**Oakland City Planning Commission
Design Review Committee**

STAFF REPORT

Case File Number: ZP160026

February 22, 2017

VIEW OF PARKING GARAGE
1431 JEFFERSON STREET

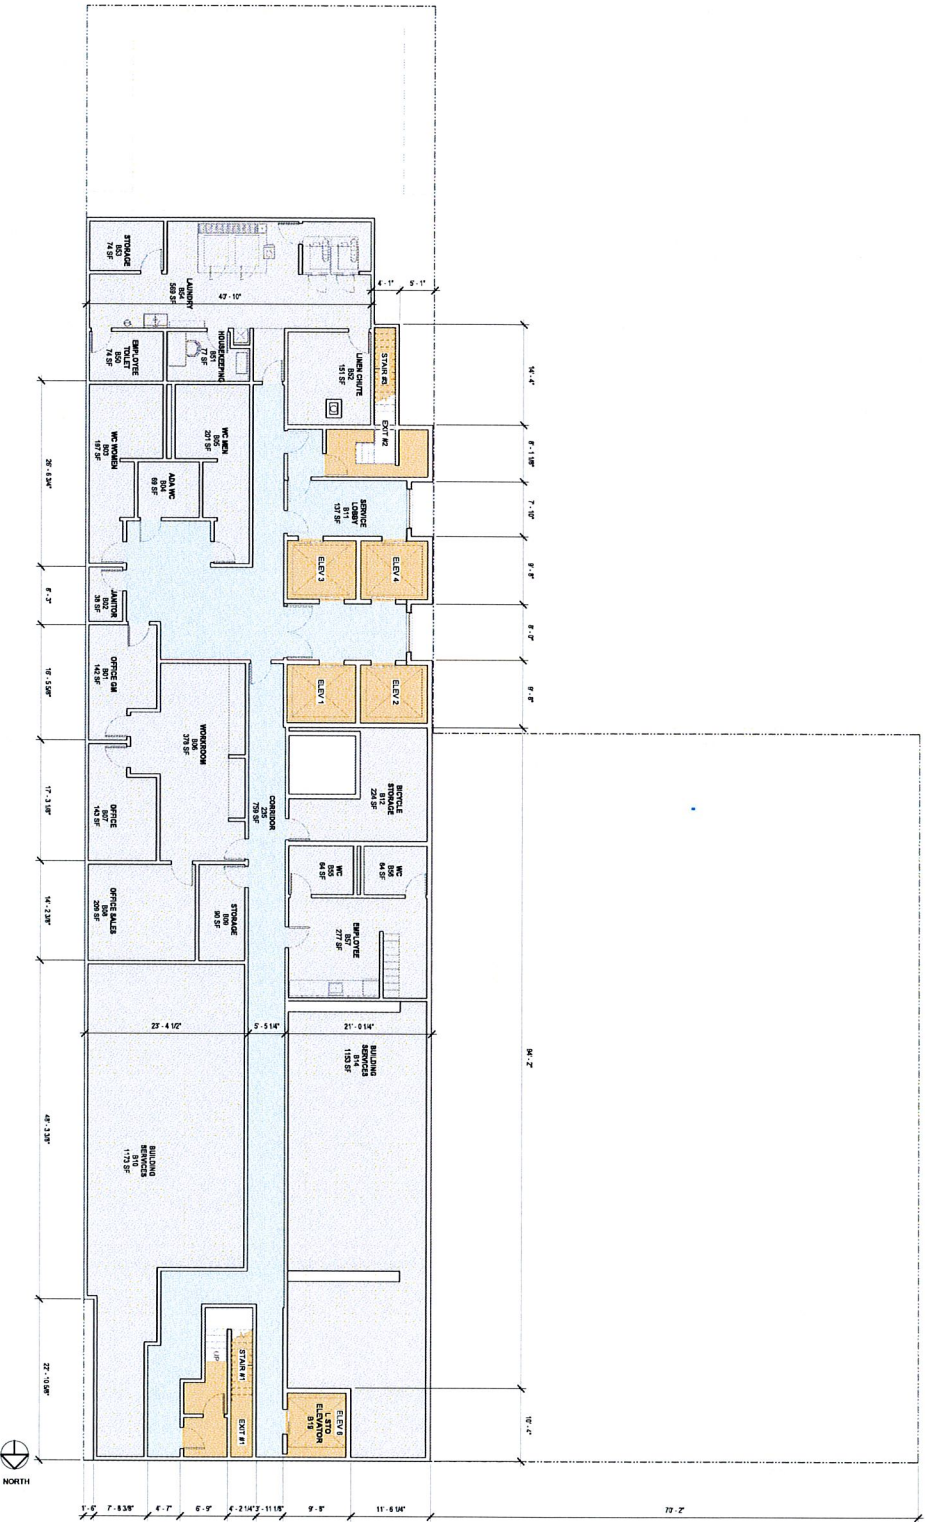
consider the installation of future street amenities including new underground utilities.
GENERAL COMMENTS	REVISED PLANS	STAFF COMMENTS
Planning Staff:		
Provide more refinements to the garage north and west sides. The panels could have two color tones or include aluminum and wood finishes to relate to the tower façade.	The previously proposed angle panels and sliver windows around the garage were replaced with a single plane wall that contains synthetic "reflectit" panel system with reveal-joints and large open-air grill frames.	The revised four-story garage does not quite integrate some of the key design features and material components from the main building. It is suggested that further development is made to create a compatible and stronger design.
Submit design details and sections of the storefront, awnings, garage/delivery doors, exterior lighting, landscaping and business signage.	See revised plans received on February 3, 2017 for more details.	It is suggested that further details are submitted for the proposed landscaping. The plan needs to include quantity, species type and size of street trees including style of tree wells. Although the revised plans show new business signage around the building, it is suggested that further details are submitted to determine the type and maximum size of signage.

EAST ELEVATION - JEFFERSON STREET
1431 JEFFERSON STREET

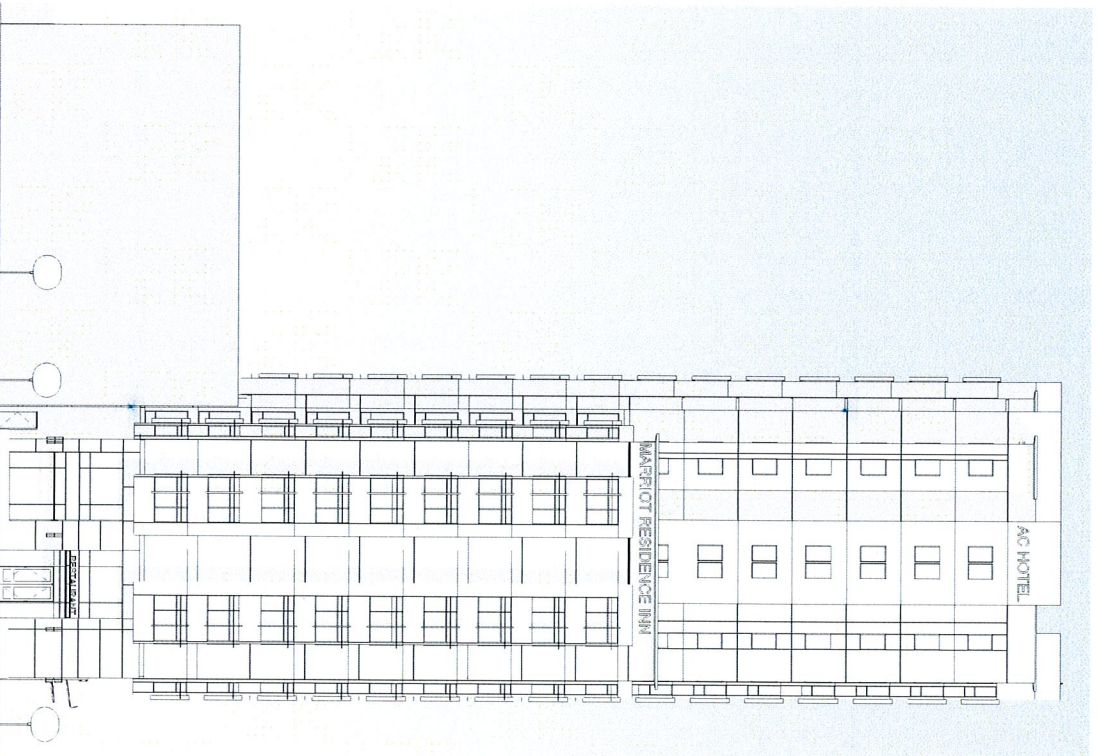
GENERAL COMMENTS	REVISED PLANS	STAFF COMMENTS
<p>Design Review Committee:</p> <p>Develop further the east side (Jefferson Street) of the building to break-up mass.</p>	<ul style="list-style-type: none"> ○ The bay windows along Jefferson St have been rearranged to make the building façade symmetric. ○ The windows in the upper levels have been reduced in size. 	<p>The rearrangement and addition of bay windows, roof eaves and wall reveal-joints are an improvement to the building façade</p> <p>However, the replacement of the larger windows with smaller windows between floors 12th and 18th may not help with the design concept and composition of the building. It is suggested that the project include a mix size of windows on the upper floors (not on the bay windows).</p>
<p>Improve the garage to provide a unified design and visual appeal.</p>	<p>The garage envelope has been redesigned to relate to the tower. The sliver windows were replaced with three large open-air grilles on 15th Street. Four additional open-air grilles and wall-flushed landscaping have been added to the west side of the four-story garage wall.</p>	<p>The seven open-air grilles including the single-plane wall and cement panels are not compatible with the project design. The garage needs further refinements to be consistent with the style of the building. It is suggested that other design options are considered to visually improve the garage north and west façades.</p>

DRAWING TITLE
VIEW OF PARKING GARAGE

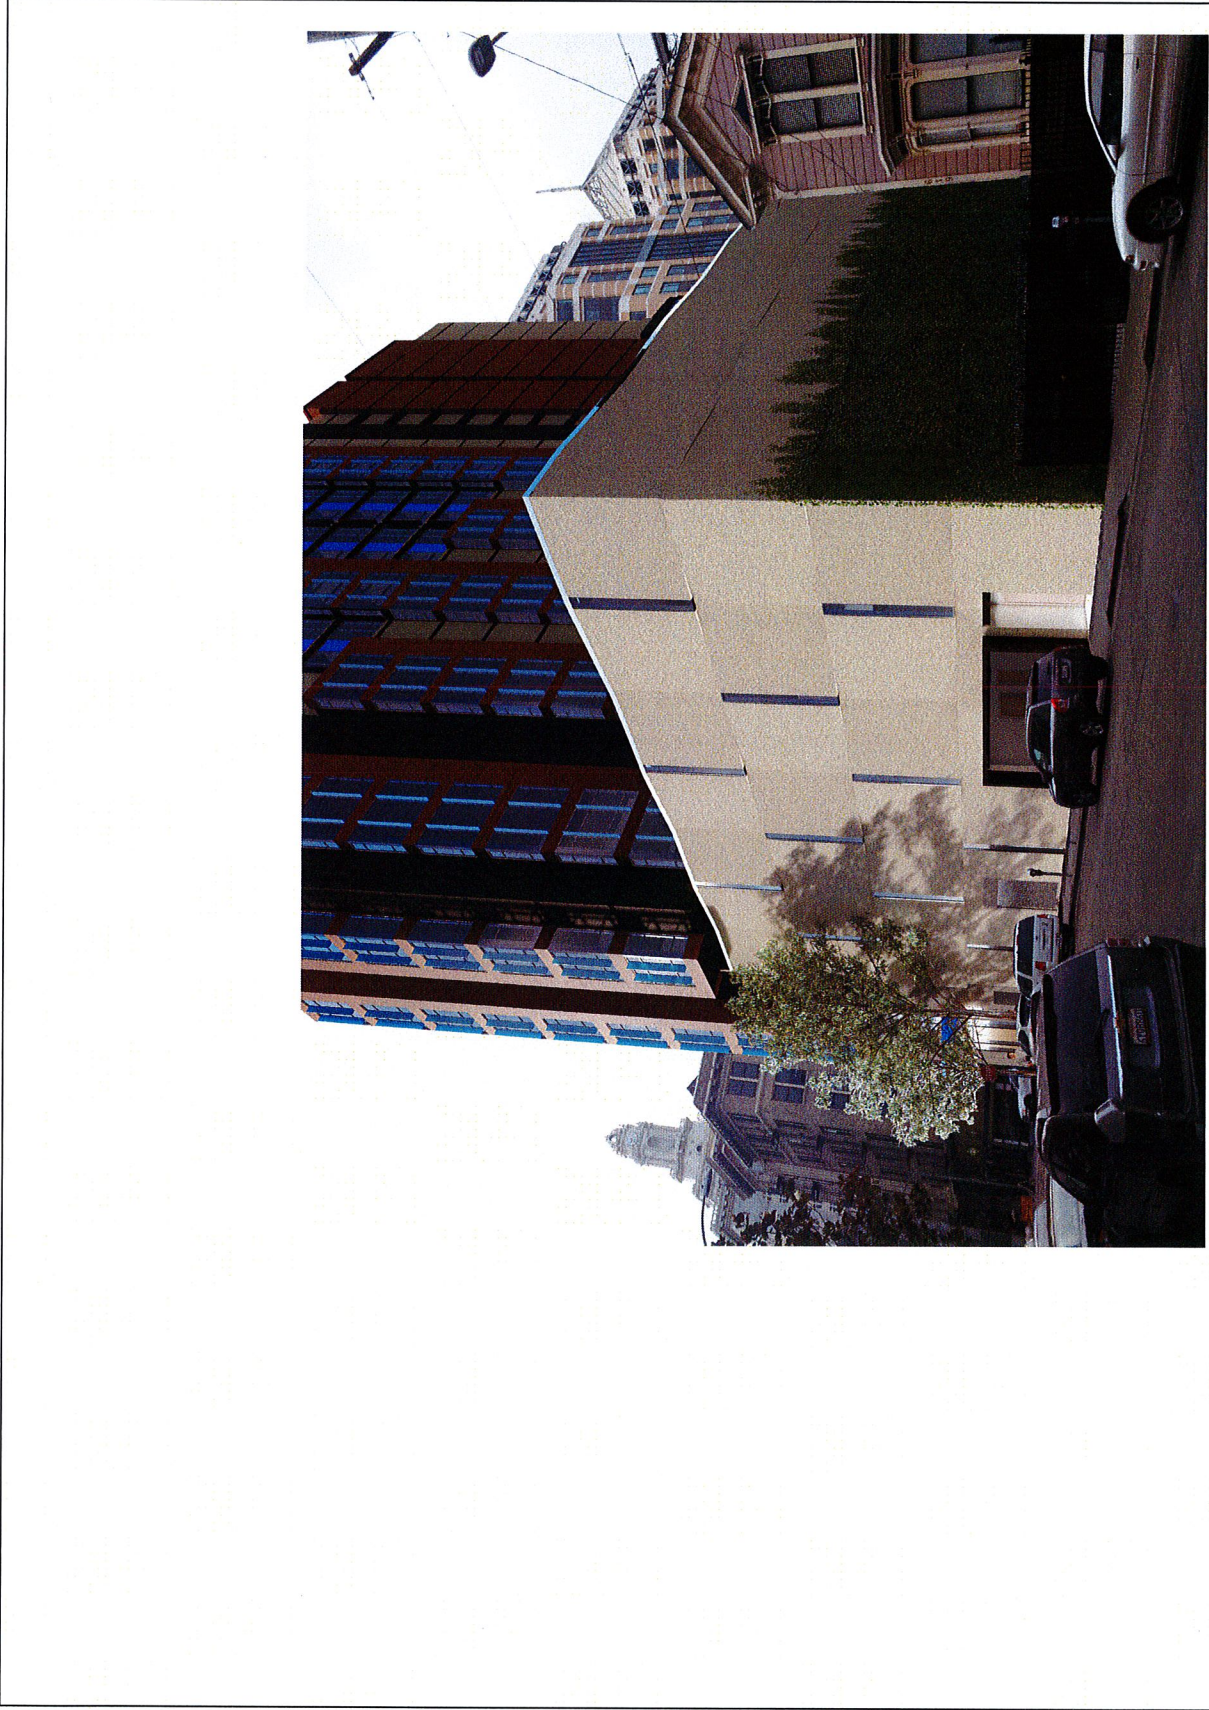
3. Consider revising the garage to provide more texture.

Response: The facade of the parking garage has been revised to read as a set of broken planes refer to A501, A027, A028, A029. A031.

DRAWING TITLE
WEST ELEVATION

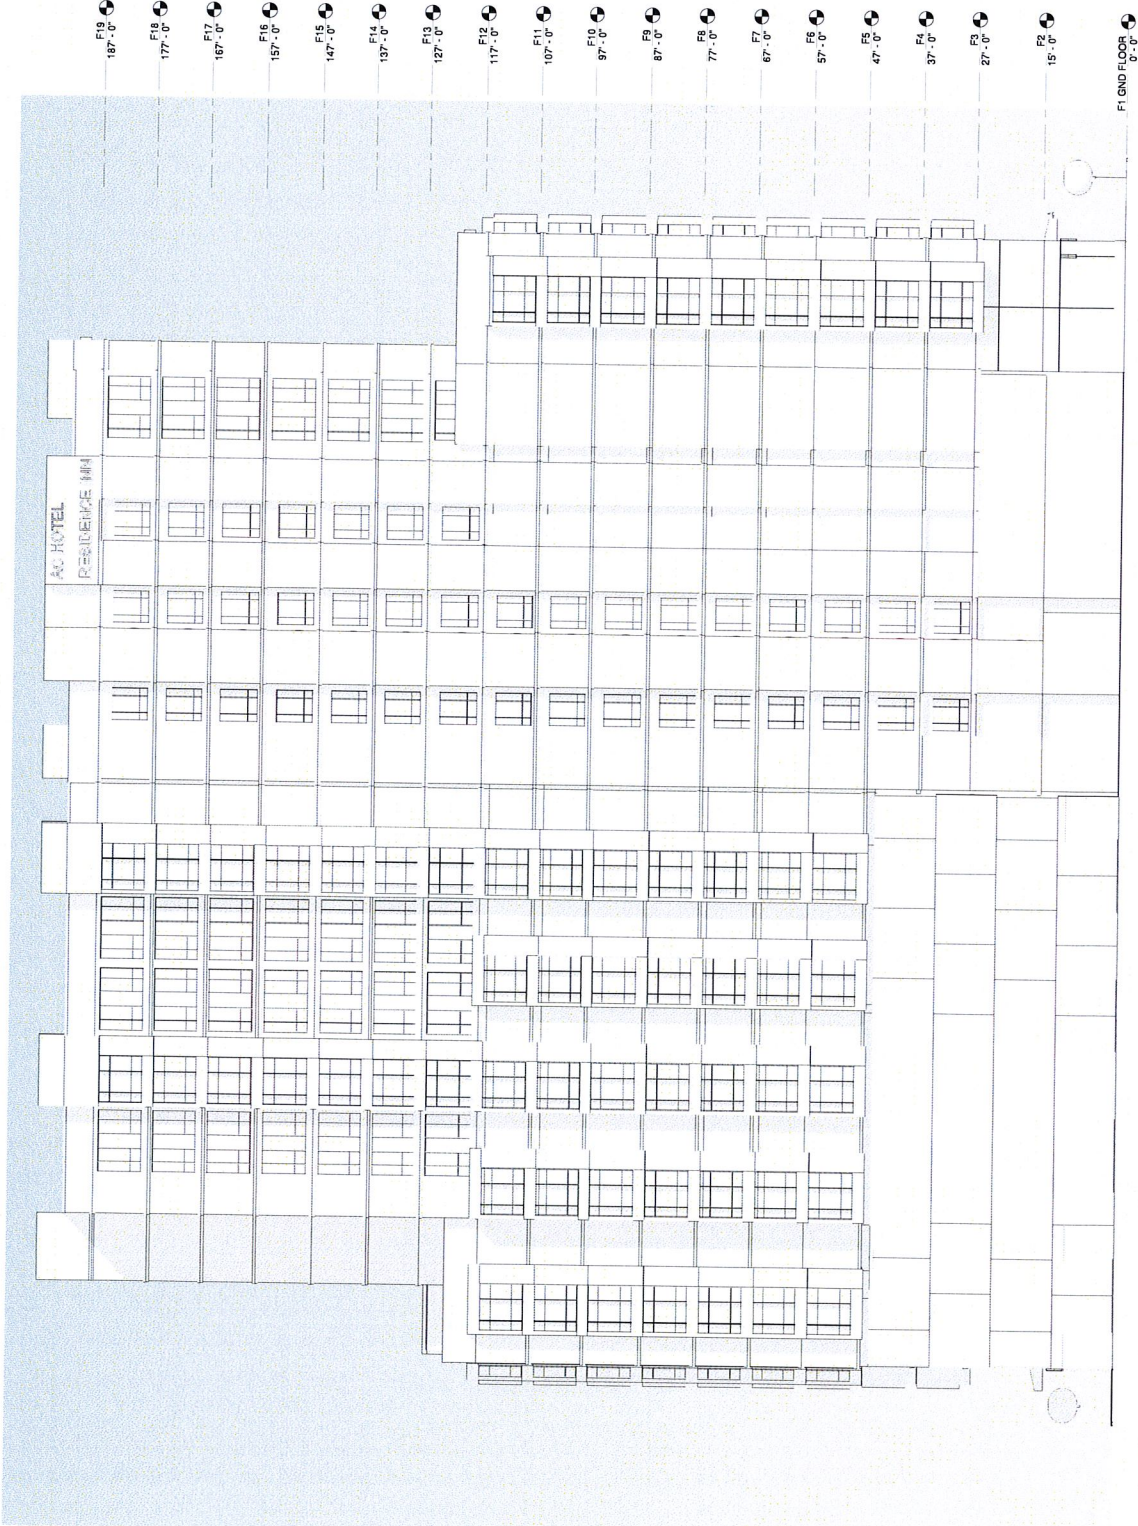
4. Reduce west facade blank wall.

Response: The west facade has been revised, a set of 3 strong recesses have been added at the south end and windows have been added to reduce the blank wall read. See A504.
